**From:** Prue Rydstrand  
**Sent:** 14/08/2024 9:46:22 AM  
**To:** Council Northernbeaches Mailbox  
**Cc:** Chris Gough; Nic Sproats; Stephanie Willis; Stephanie Vatala  
**Subject:** TRIMMED: DA2022/0469 - LEC 2023/242901 objections  
**Attachments:** Submission\_-\_Rydstrand - NBC.pdf; Submission\_-\_Dentons\_Australia\_Limited.pdf;

**Northern Beaches Council ats Asia Digital Investments Pty Ltd**  
**Land and Environment Court Proceedings No. 2023/242901**  
**Development Application: DA2022/0469**  
**Property: 1102 Barrenjoey Road, Palm Beach**

**Annexure A – Massing Height Control Plans**

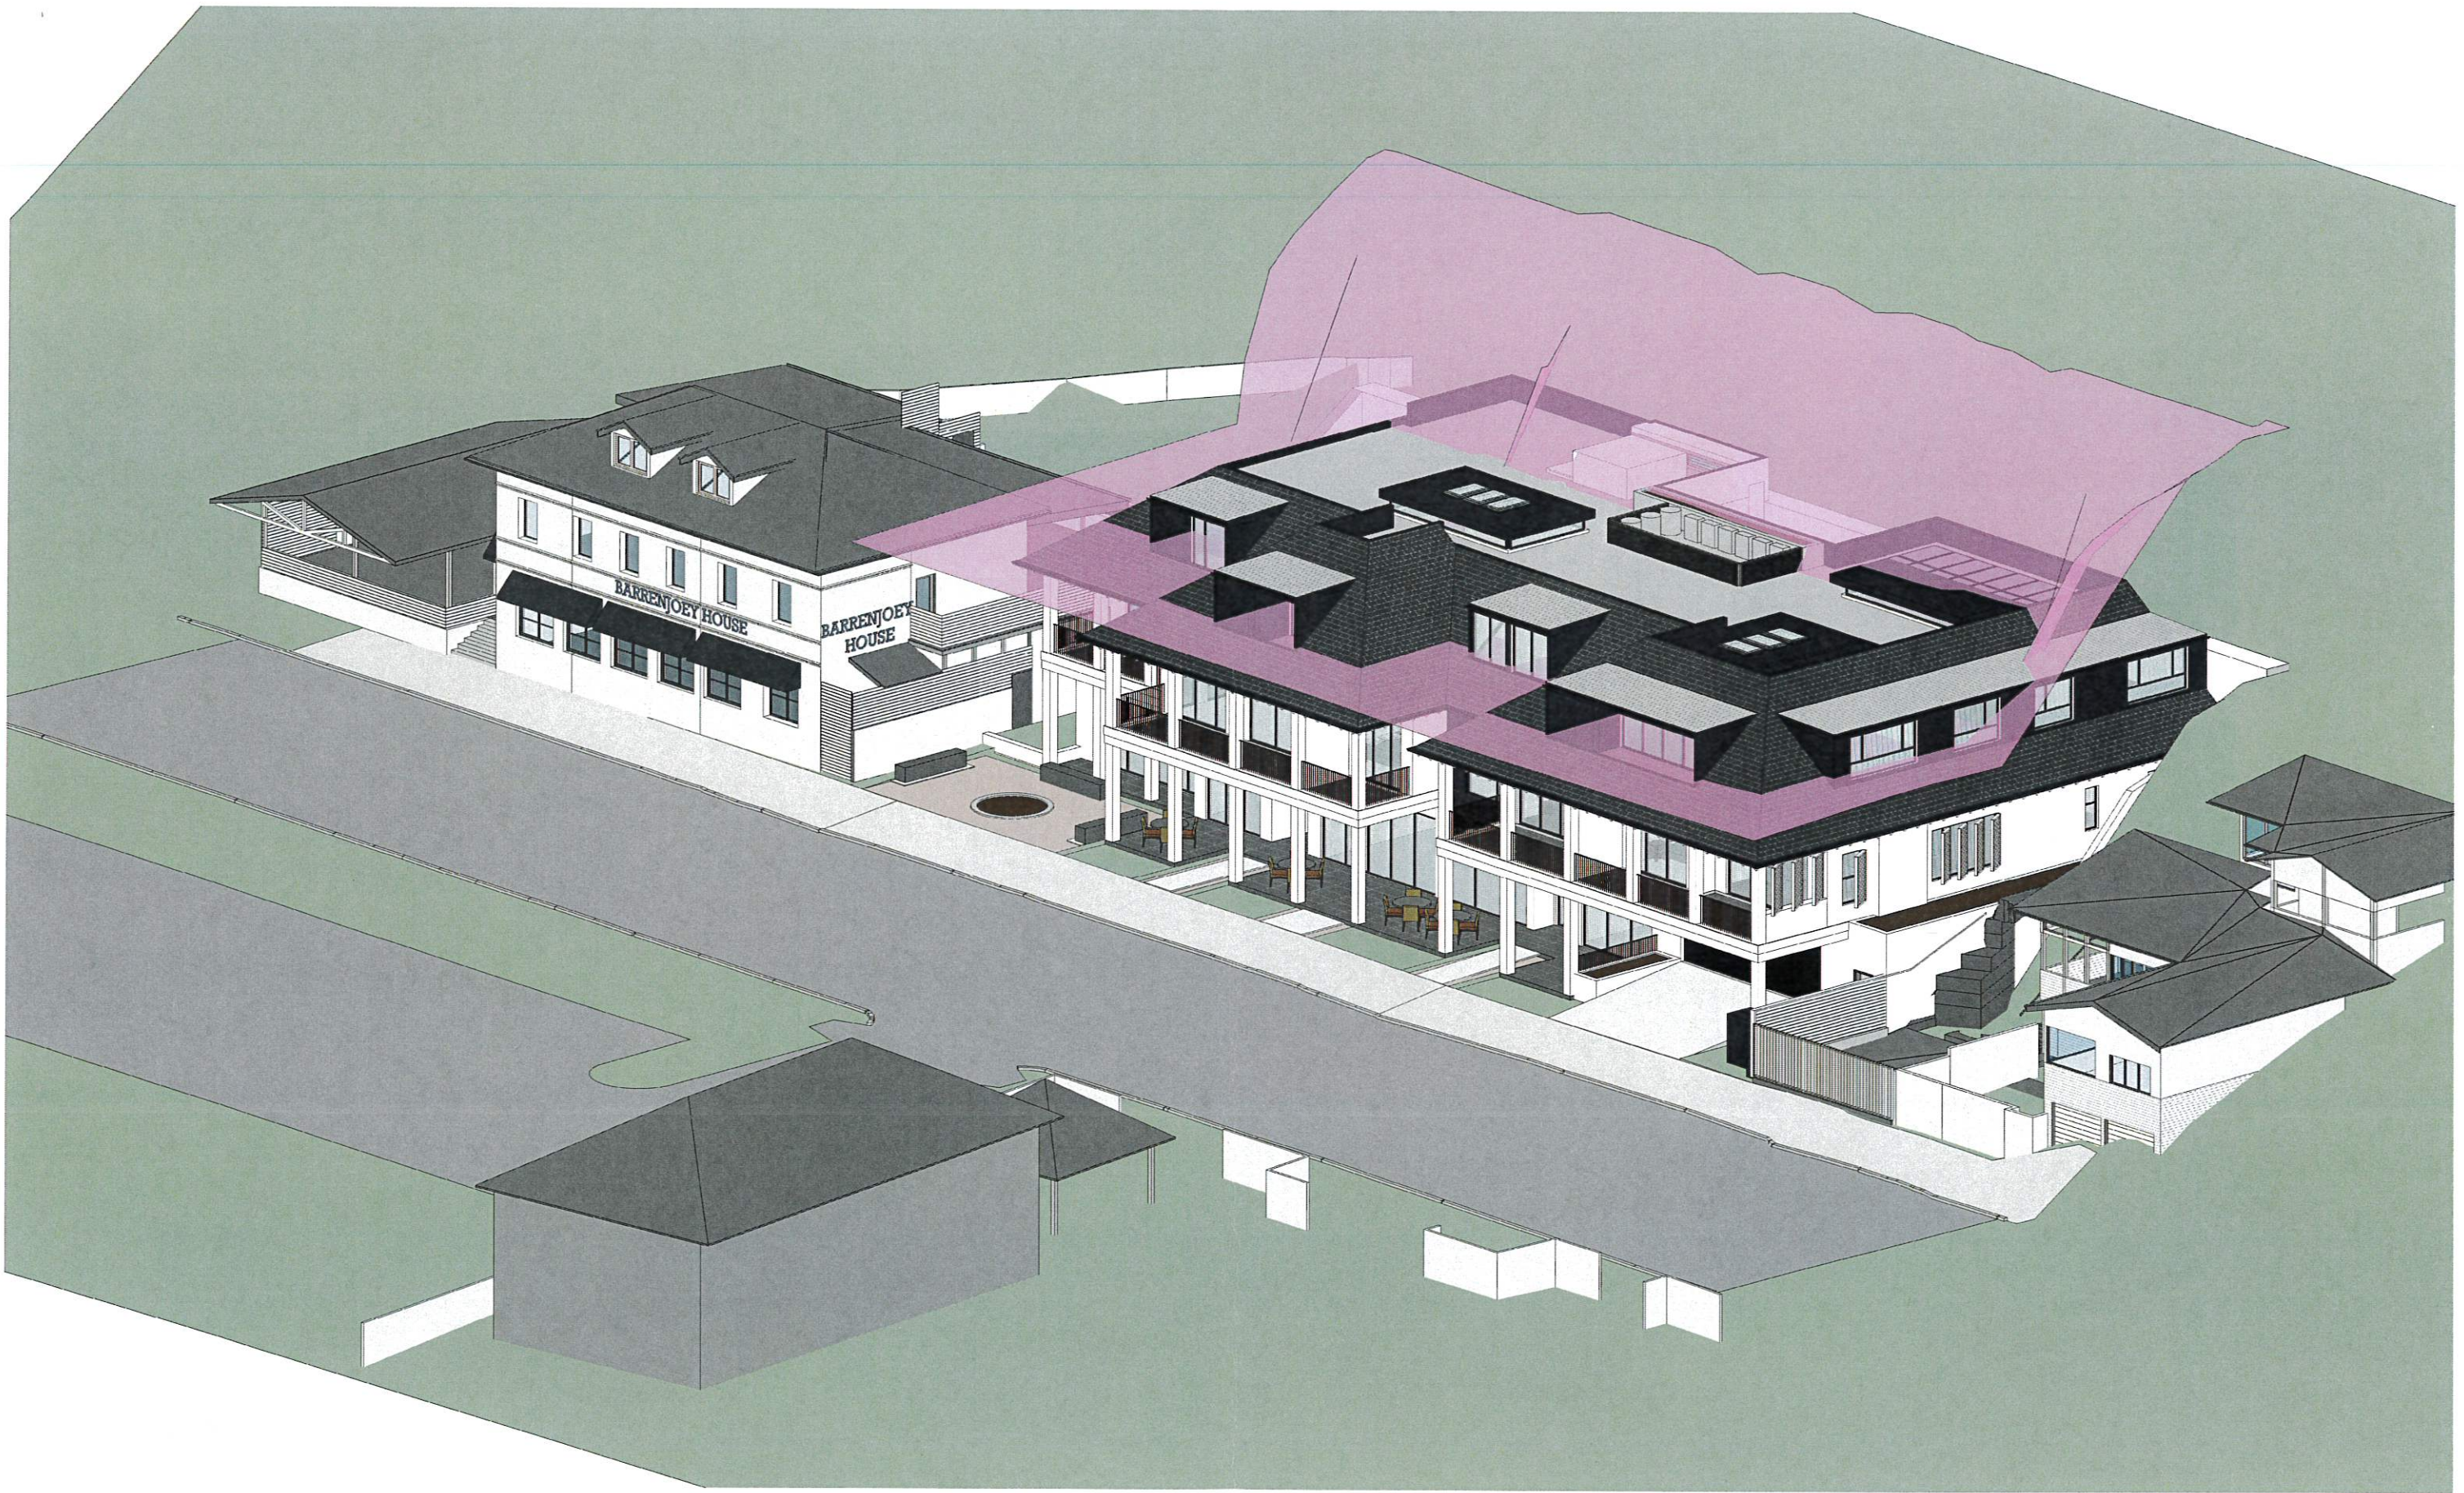
6. Firstly, insofar as the relationship of the proposed development to our client's property at 1100 Barrenjoey Road is concerned, there is no material difference between the amended set of plans (Revision D) and the prior set of plans (Revision C). This is best demonstrated by the "Massing Height Control" plans included in **Annexure A** to this letter, which show that the massing of the proposed building remains the same.
